DOCUMENT TRANSMITTAL 2003-55196

TRM2 - TECHNICAL REQUIREMENTS MANUAL UNIT 2

# **Susquehanna SES Unit 2 Cycle 12**

## **CORE OPERATING LIMITS REPORT**

MCPR OPERATING LIMIT VERSUS CORE POWER  
EOC-RPT INOPERABLE / MAIN TURBINE BYPASS OPERABLE  
TWO LOOP OPERATION (BOC to EOC)  
FIGURE 5.2-6

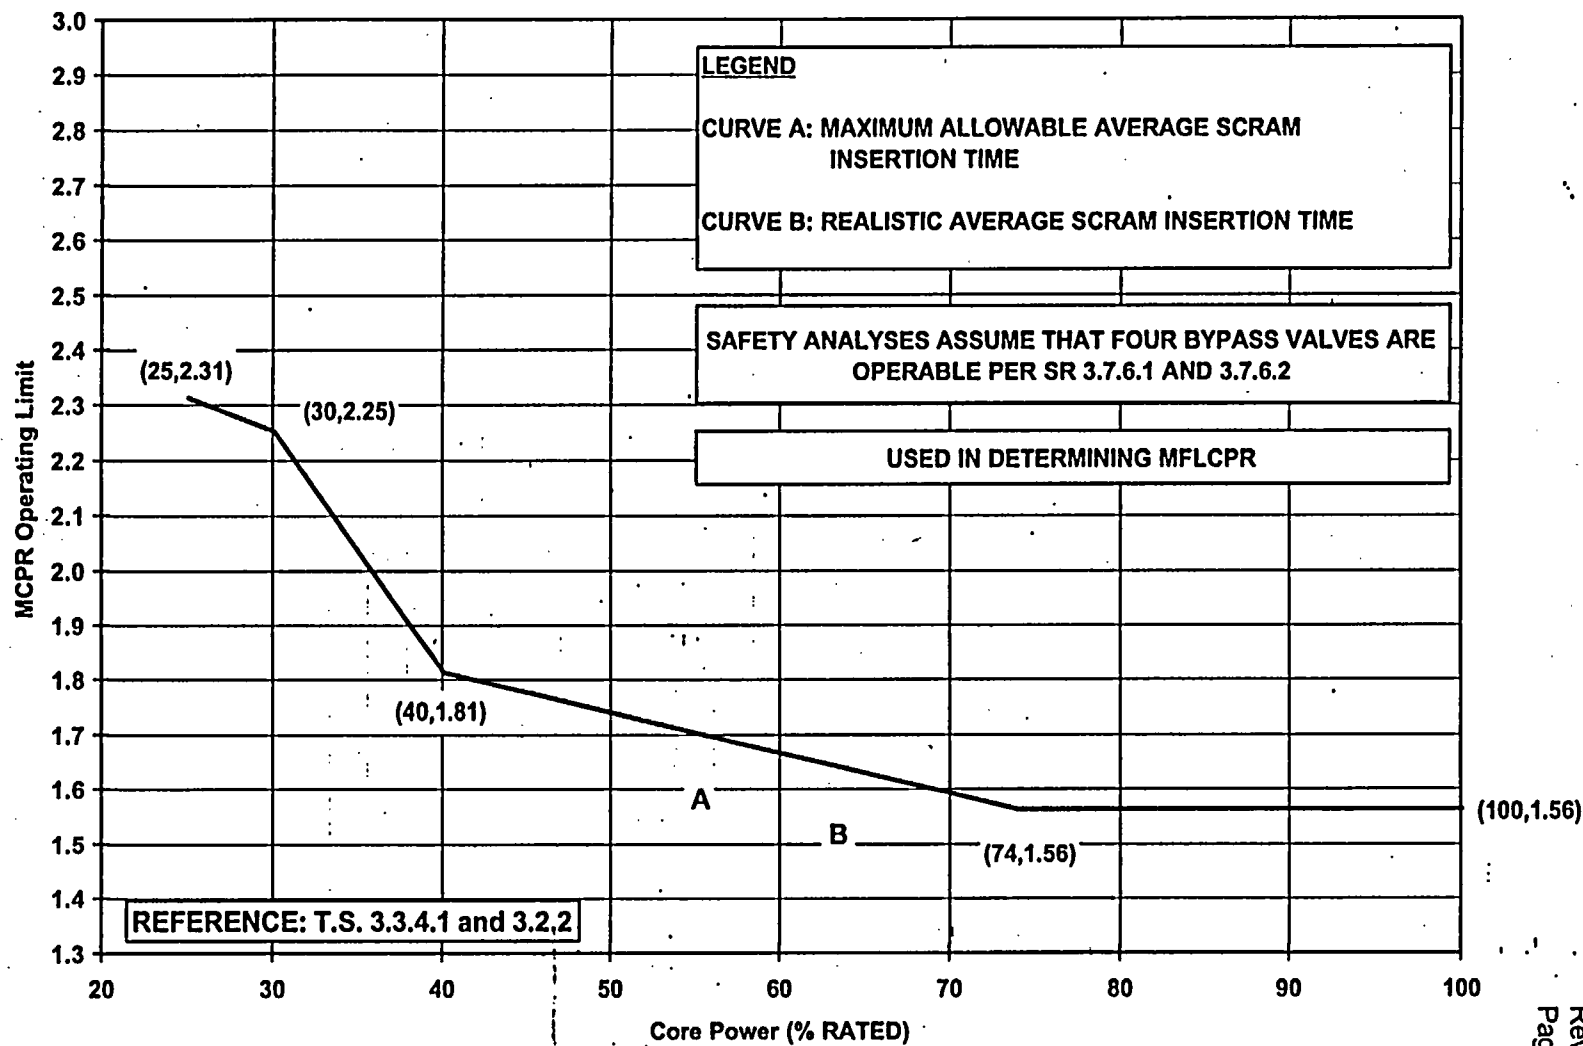
Rev. No.	Affected Sections	Description/Purpose of Revision
0	ALL	Issuance of this COLR is in support of Unit 2 Cycle 12 operation.
1	5.0 6.0 8.0	<p>This revision adds a text box to all appropriate plots. This text box indicates that for all bypass operable cases, four bypass valves are assumed operable. For the bypass inoperable cases, the text box indicates that two or more bypass valves are assumed inoperable.</p> <p>This revision was generated in response to Facility Operating License Amendment 185 which altered SR 3.7.6.1.</p> <p>This revision is administrative in nature and no underlying calculations or plotted data were altered.</p>
2	TOC 1.0 9.0 10.0	<p>This revision adds the Power / Flow map to the COLR. Section 1.0 was revised to include the stability regions as part of the COLR. The Power / Flow map was added as Section 9.0. The Reference section was renumbered as Section 10.0 and a stability reference added.</p> <p>This revision is administrative in nature since the Power / Flow map is already included in NDAP-QA-0338.</p>
